**Subject** ▶ Change on gear housing complete and plate

**For Models** ▶ JR3000, JR3000V and JR3001 (Recipro Saw)

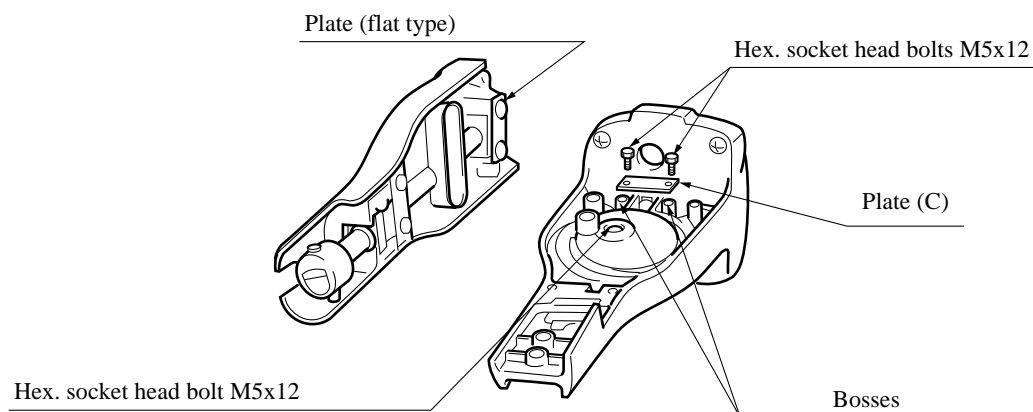
- Description** ▶
1. A plate (C) will be added.
  2. Bosses will be added to the gear housing complete to accept the plate (C).
  3. Hex socket head bolts M5x12 will be added to install the plate (C) on the gear housing complete.
  4. The plate for installing the plane bearing will be changed from L-shaped to flat type.
  5. The countersunk head screw M5x12 for securing the flat washer 6 will be changed to the hex. socket head bolt M5x12.

Item No.	Current part		Q'ty	I/C	New part		Q'ty	
70					Plate (C) 343981-8		1	Interchangeable as a set
19	Gear housing complete 159679-5		1	No	Gear housing complete 159718-1		1	
12					Hex. socket head bolt M5x12 251969-3		2	
6	Plate 343526-2		1	No	Plate 341462-6		1	
12	Countersunk head screw M5x12 251372-8		1	Yes	Hex. socket head bolt M5x12 251969-3		1
